COMMUNITY PLANNING

Response to Third Referral (dated 11/24/2009; received 12/7/2009)

Kincora Development

Figure A: Road Phasing Plan - Phasing by Land Bay

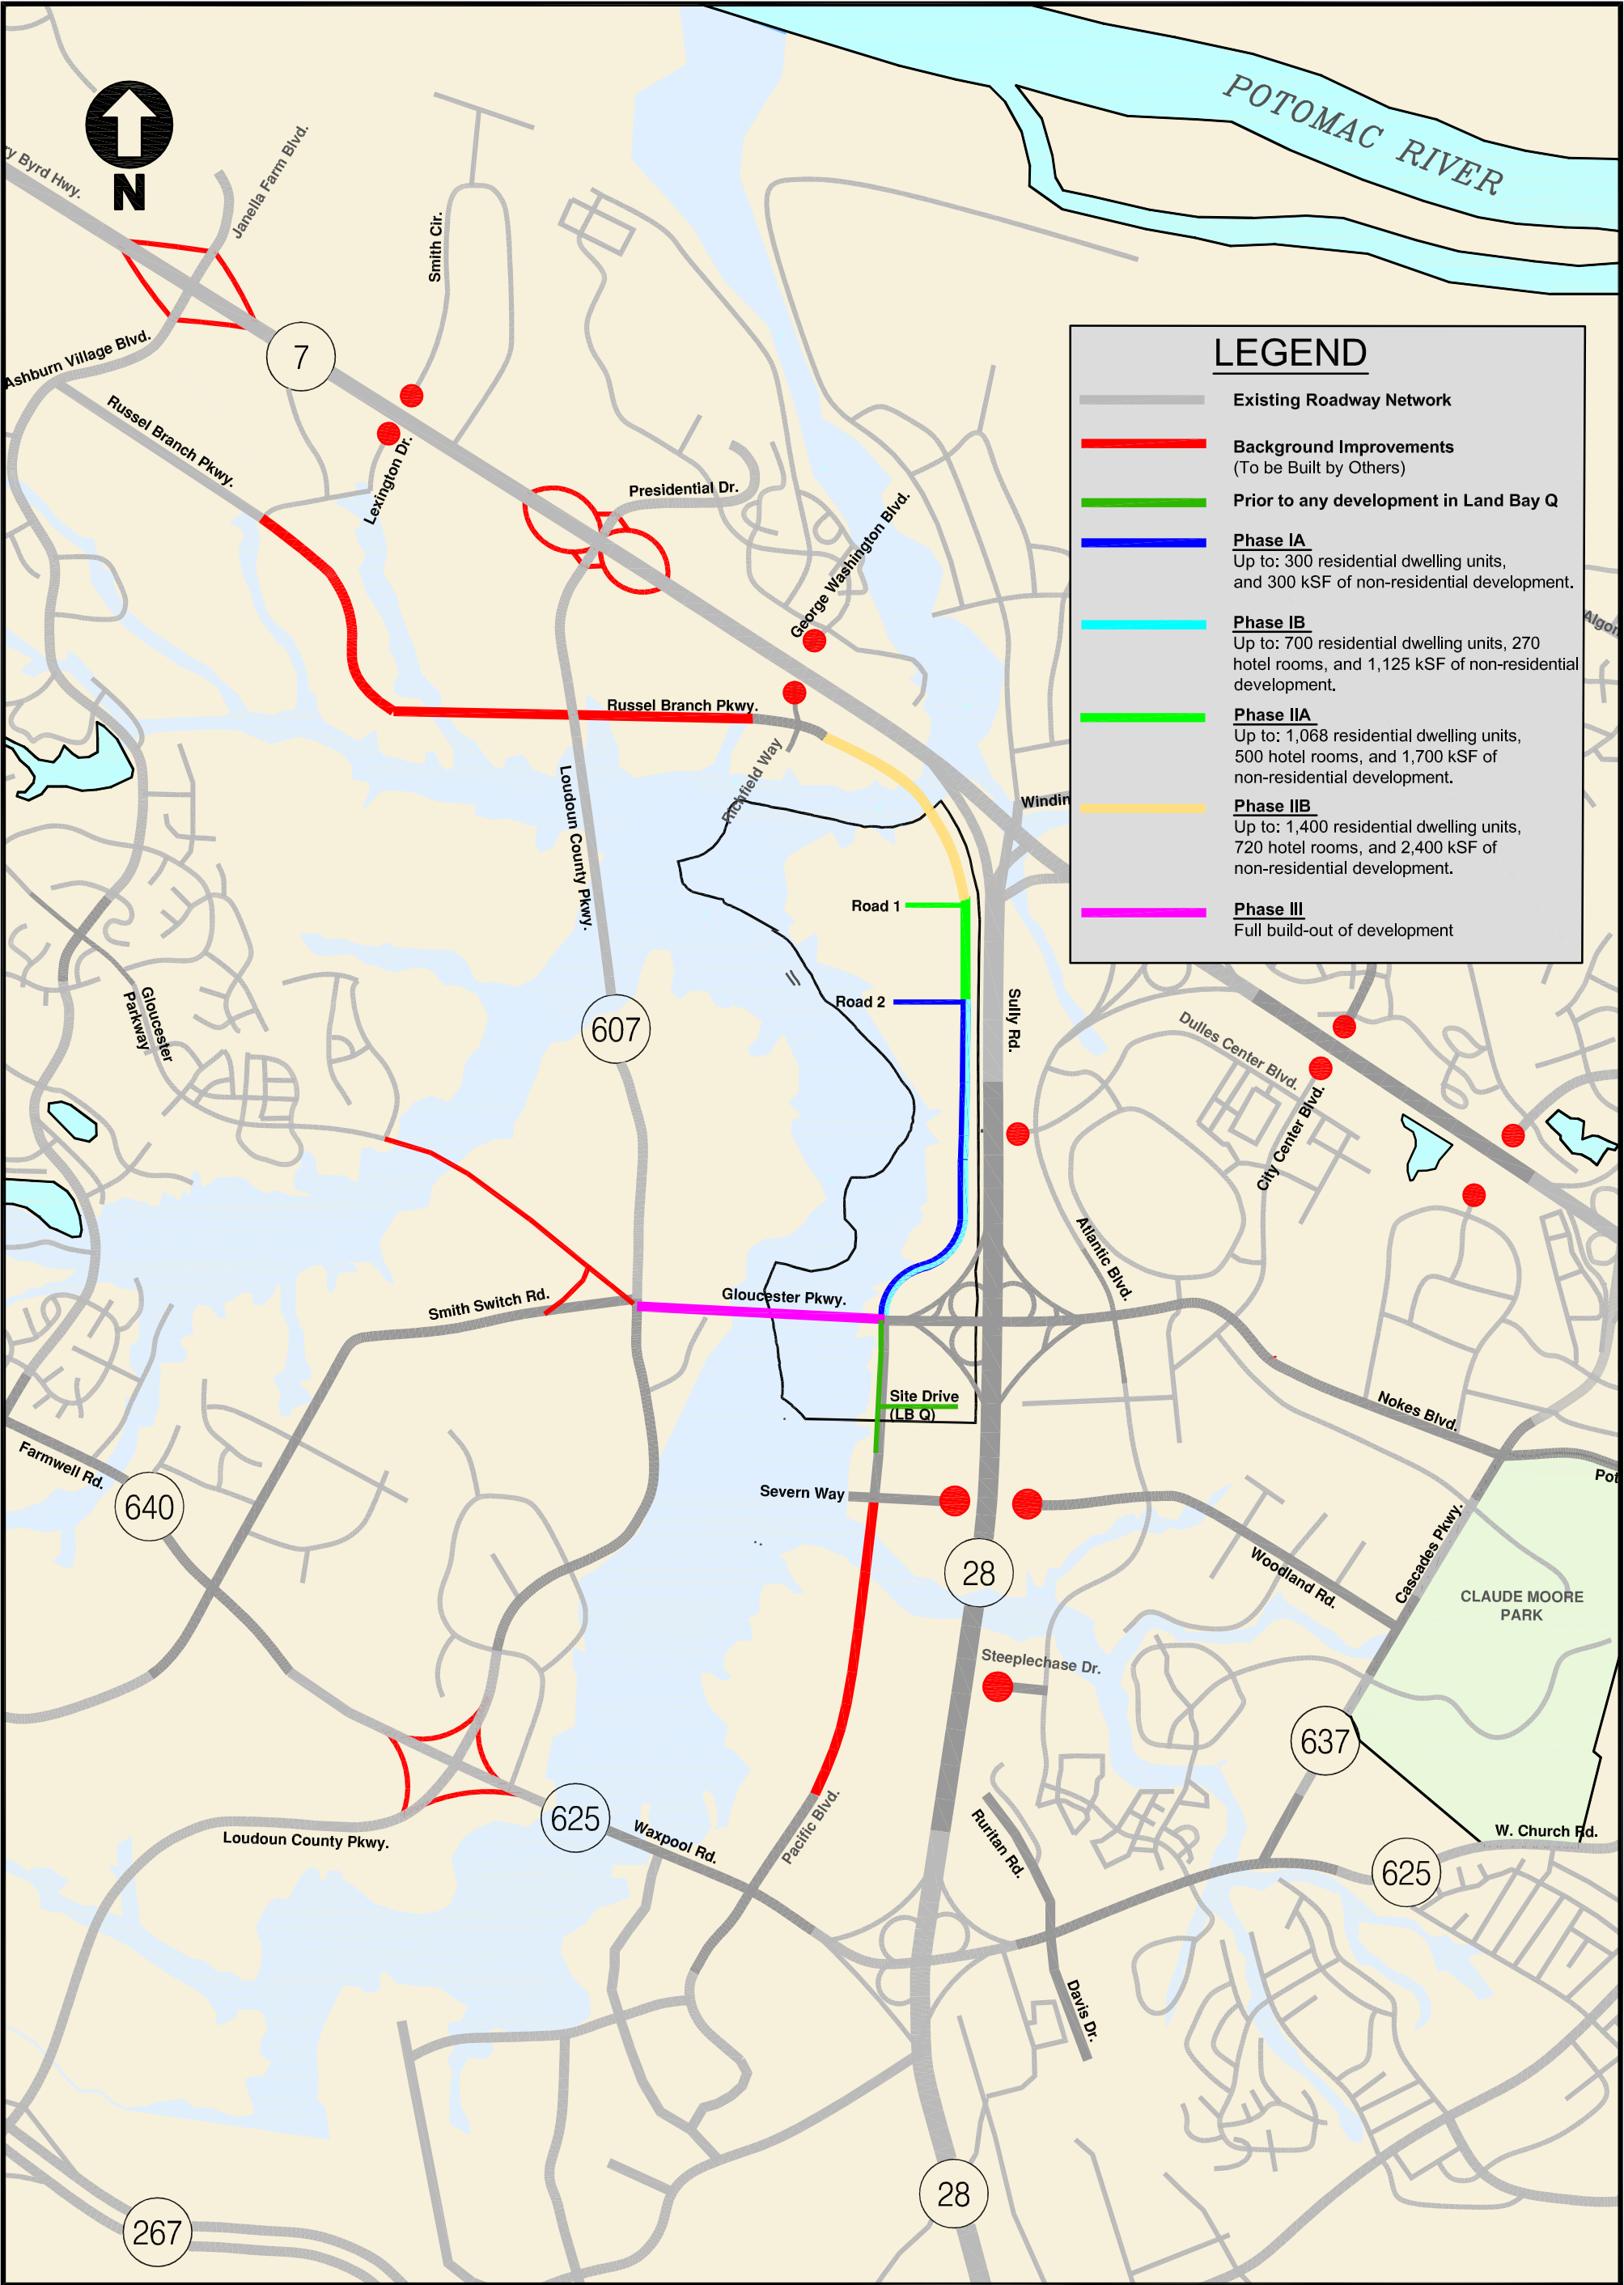
11. **AGREE**. A sketch depicting the general transportation phasing of the project is attached. The details of the individual road improvements will be provided with the construction plans and profiles and site plans.
